## Town of Atherton

July 7, 2016

RE: Comments on the Facebook Campus Expansion Project Draft Environmental Impact Report,  
SCH# 2015062056

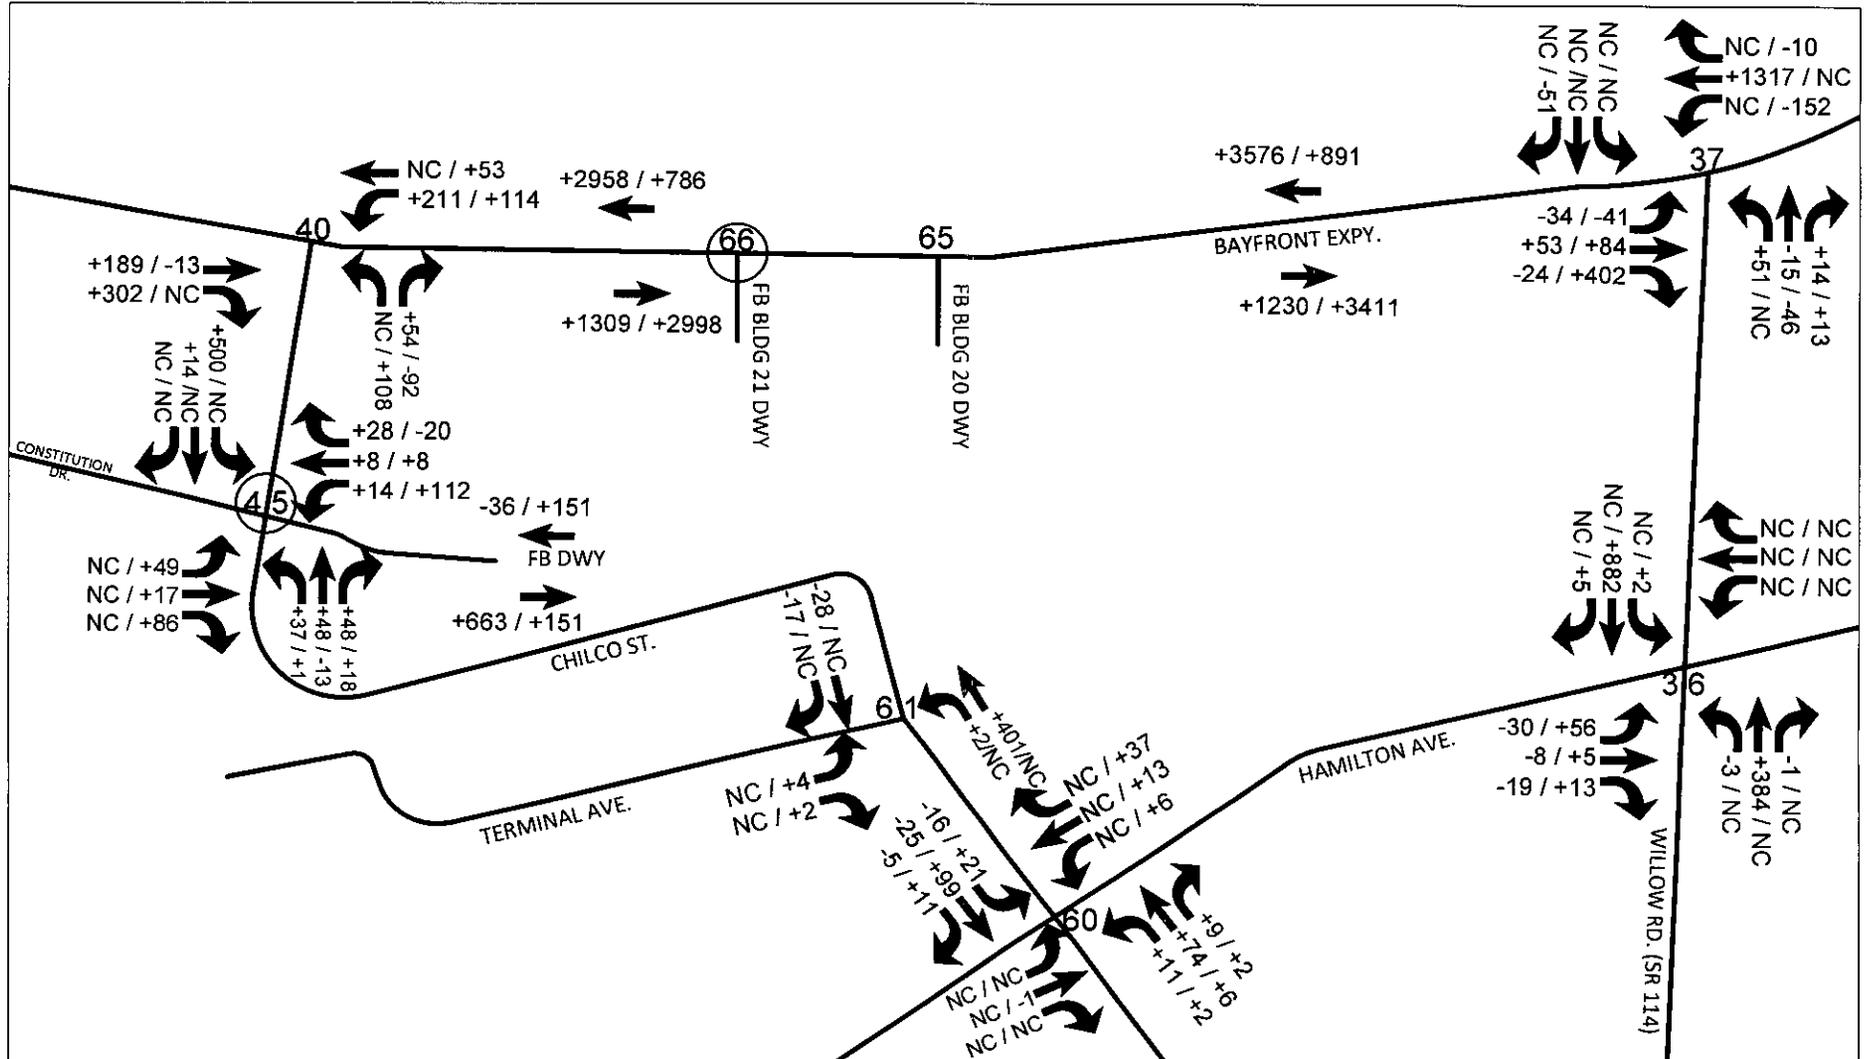
The DEIR for the Facebook Campus Project, which included Building 20, showed that that project would have significant impact on the intersection of Middlefield & Marsh under cumulative conditions. Figure

3.5-20 from that document (attached), shows that 319 and 321 of the Facebook Campus project's trips would go through that intersection (#7) during the AM and PM peak hours, respectively. This is far greater than the -40 and +25 derived Project trips from the current Facebook Project that would go through the intersection (#64) during the AM and PM peak hours, respectively, even though the trip cap is similar for each of the Facebook developments, and the currently proposed development is closer to the study intersection. This suggests that one or both of the studies is in error and casts doubt on the accuracy of the analysis for the current Project.

ATHERTON COMMENTS EXHIBIT 1  
 DERIVED PROJECT AM / PM PEAK HOUR TRAFFIC VOLUMES  
 INTERSECTIONS IN PROJECT VICINITY  
 BACKGROUND (2020) CONDITION

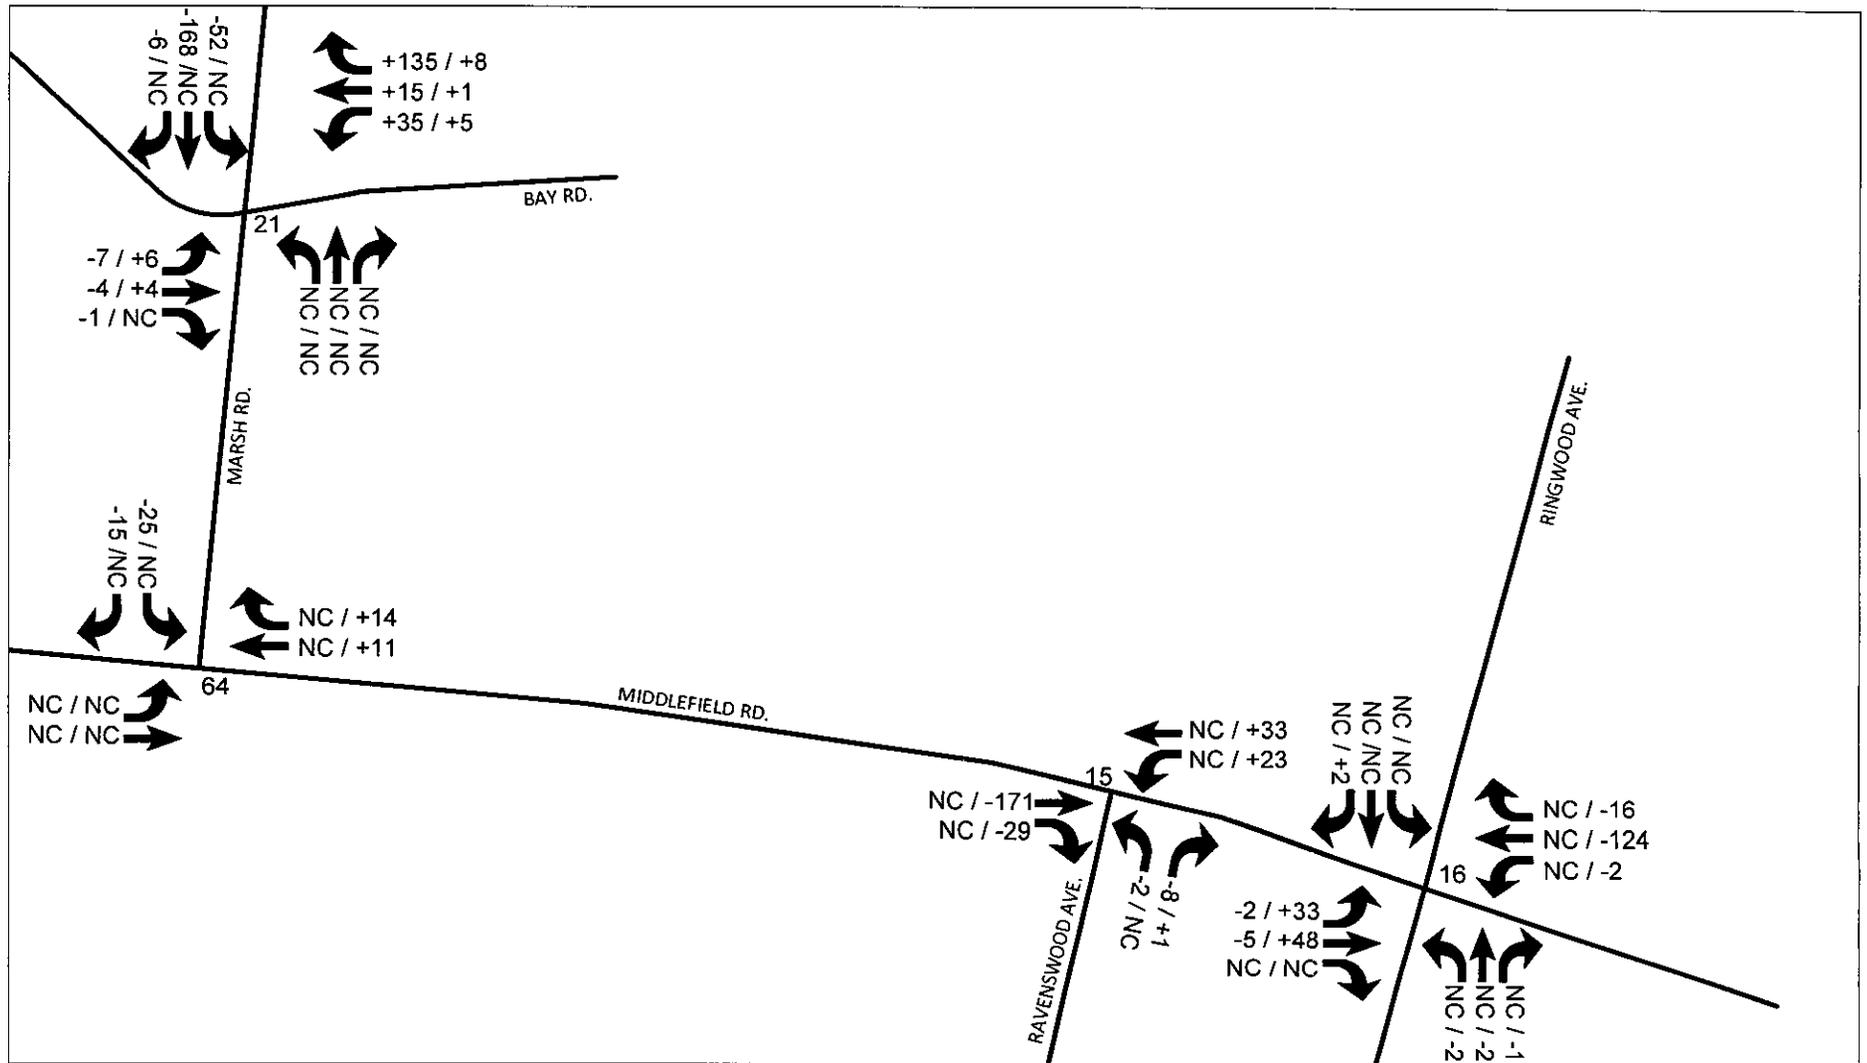
deriving the AM/PM peak hour project volumes from the scenario volumes provided in the appendices by subtracting the Baseline traffic volumes from the Baseline + Project volumes. These derived project traffic volumes are illustrated on the attached Atherton Response Exhibits 1-6, for Background and Cumulative 2040 conditions, for those study intersections that are surrounding the project site and those that are within the Town of Atherton.

A review of Exhibits 1-6 shows that the derived project traffic volumes are frequently negative. Also, a volume at a given intersection may be positive in the AM and negative in the PM, and vice versa. It is understood that having negative numbers is not unusual in the comparison of model-generated volumes, however, some of the negative numbers were in the hundreds of trips. The variations and large negative numbers indicate that there may be issues with the model.

In some cases, a change was shown in turning movements that appeared to be unrelated to the project, for instance, at Chilco/Constitution (#45), changes were shown for northbound left and eastbound right, movements which would not reasonably go to or from the Project site. There was a similar situation at Bayfront Expressway (SR 84)/Willow Road (SR 114) for the southbound left and westbound right movements during the PM peak hour. Were post-processing reasonableness checks performed to ensure that the project volumes made sense?

A comparison of the derived Project traffic volumes on the Atherton Response Exhibits 1-6 also shows a large difference in the derived Project traffic volumes under Background conditions versus Cumulative 2040 conditions. The Project volumes should be very similar, if not the same, for the two scenarios. The Project volumes using the existing driveway on Chilco Street are mostly the same, however, the Project volumes on Bayfront Expressway (SR 84) were quite different. The differences are shown in the table below. Since the study did not provide the without-project driveway volumes for the Bldg 20 Entrance, the Project traffic volumes for the Bldg 21 Entrance cannot be derived. Instead, the approach and departure volumes on Bayfront Expressway on either side of the two Facebook driveways were reviewed. The approach and departure volumes are based on the derived Project volumes at the adjacent intersections at Chilco Street and at Willow Road (SR 114).
